Road Safety Audit: Stage 1

**Formation of temporary construction access track
A629 Penistone Road, Birds Edge**

Plough Barn, Birds Edge Lane, Huddersfield

Produced for: Kirklees Council
Report Dated: 15 September 2026
Report Reference: RSA/ENG/170926

Photo 3 – Current speed limit signage

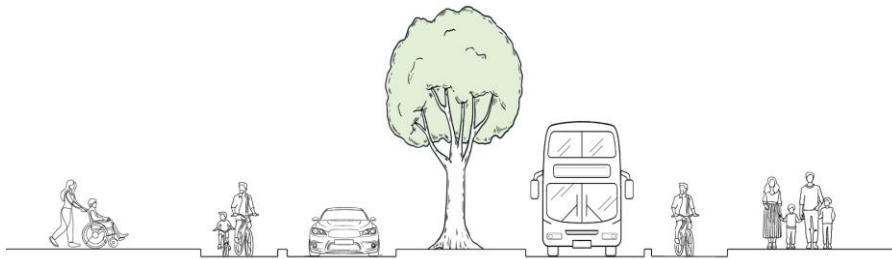
The submitted plans do not indicate the provision of any warning signage to alert drivers to the presence of a new access at this location. The absence of such signage may increase the potential for vehicle conflict, including shunt-type collisions.

The access lies within a 30mph speed limit, shown in photo 3 approximately 74 metres from the terminal signs.

Observations made on site suggested that vehicle speeds remained higher until further towards the junction with Birds Edge Lane, which may further elevate the risk of conflict at the new access.

Appropriate temporary warning signage should be provided to highlight the presence of the new access and reduce the likelihood of vehicle conflict.
